ADDENDUM NO. 2

Accessibility Audit for the Pemberton Transfer Station

Issued: June 30, 2026

PEMBERTON TRANSFER STATION

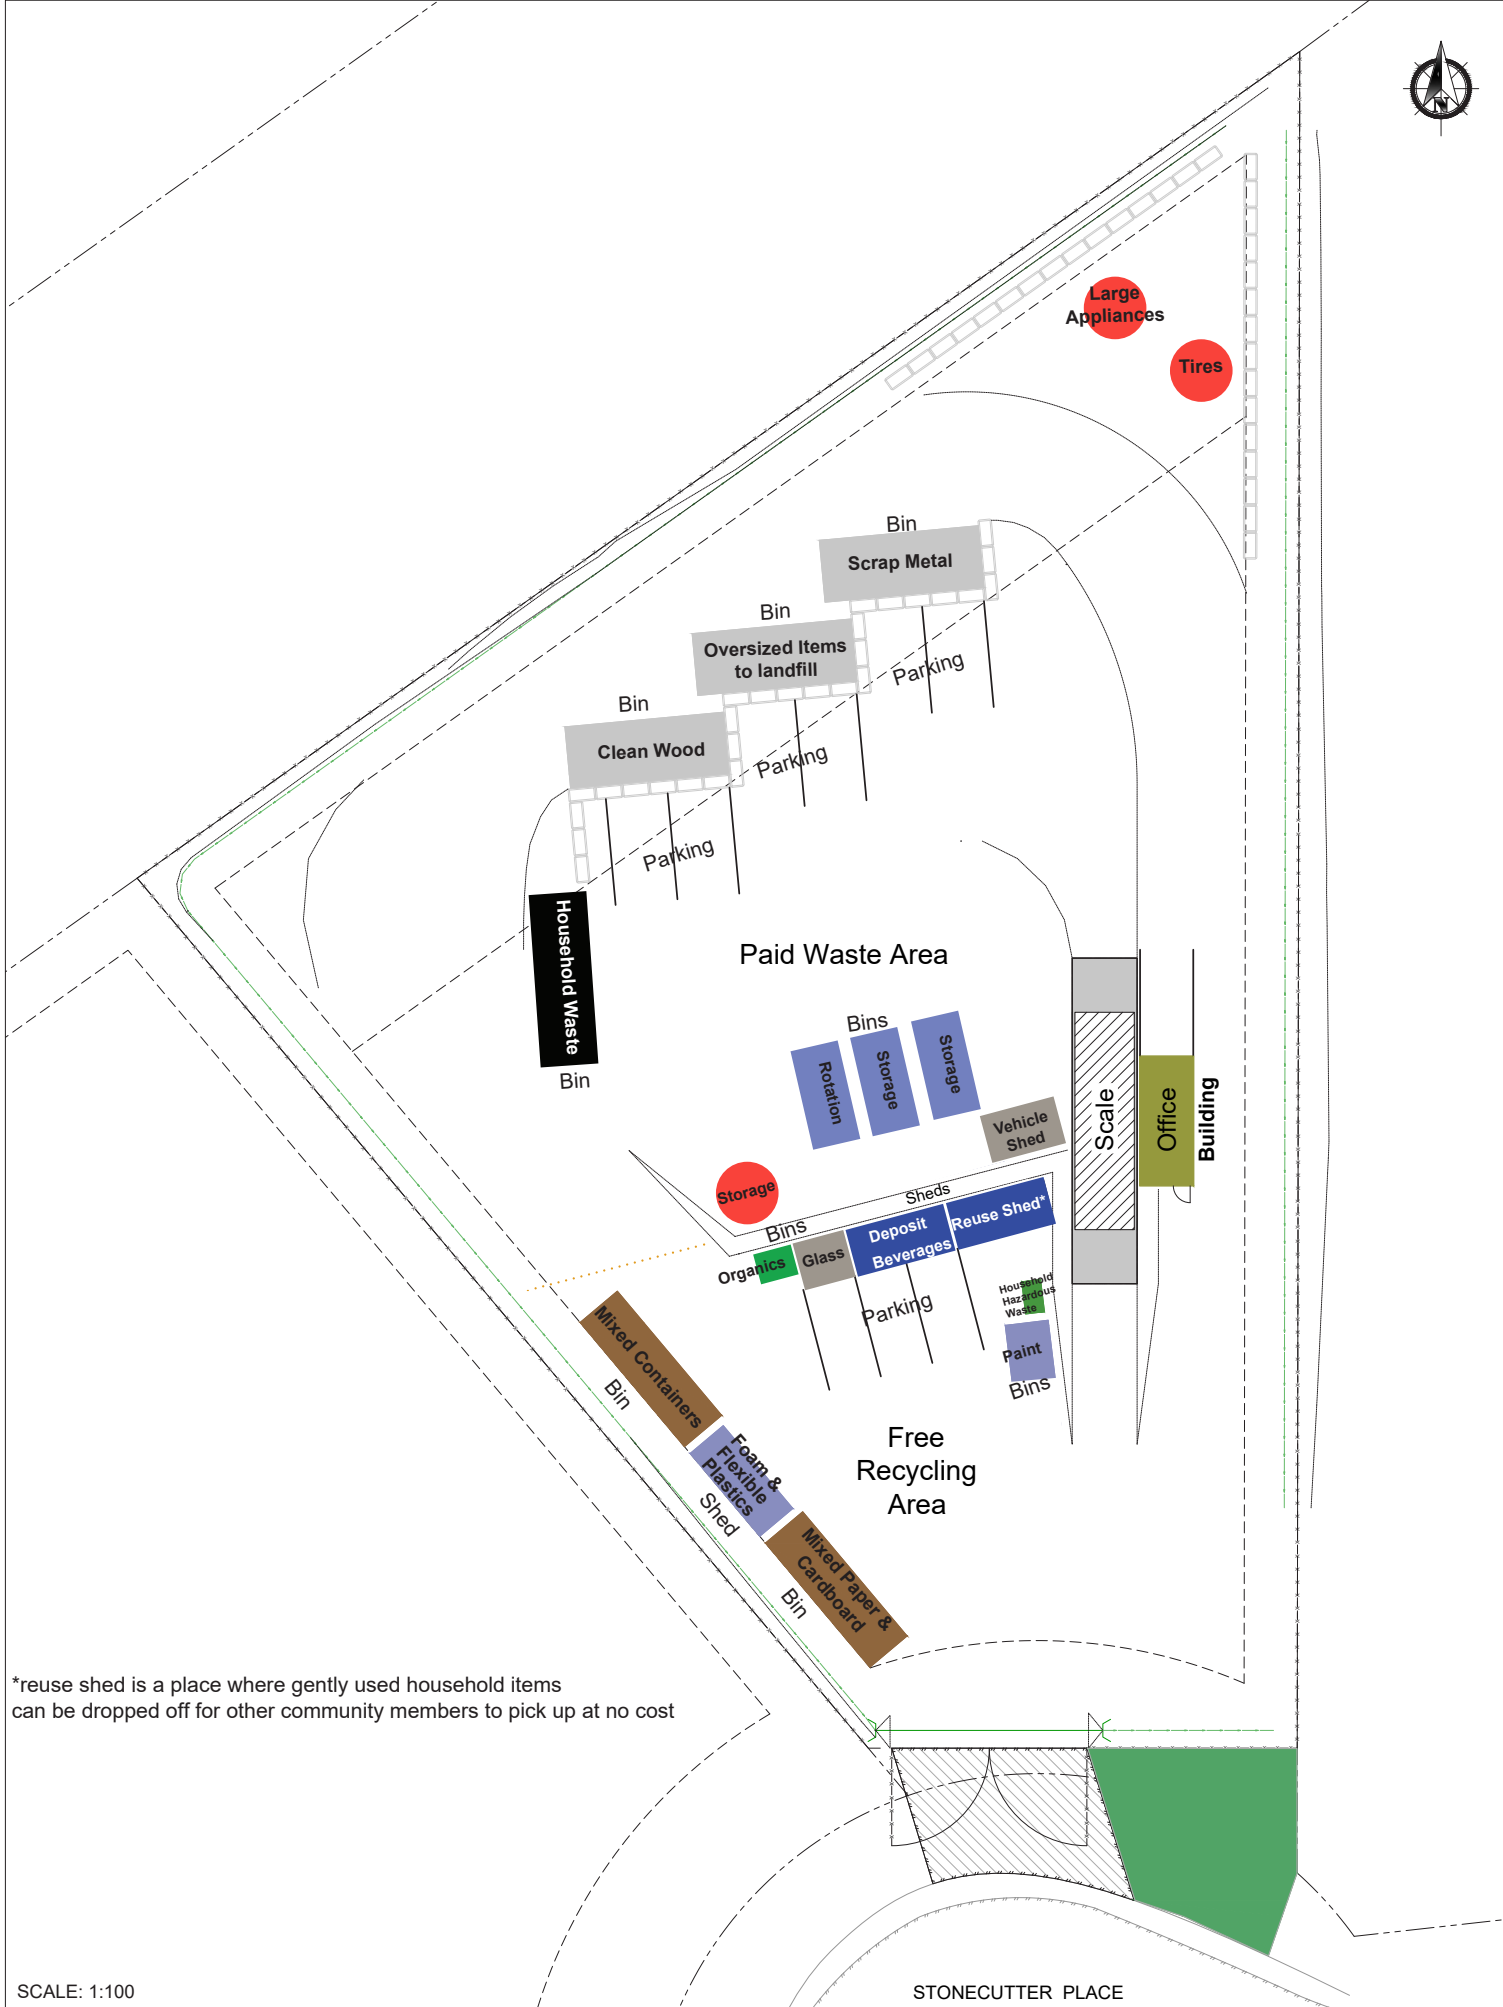
Are there any site plans labeling the property boundaries and the buildings on site?

A site plan is attached.
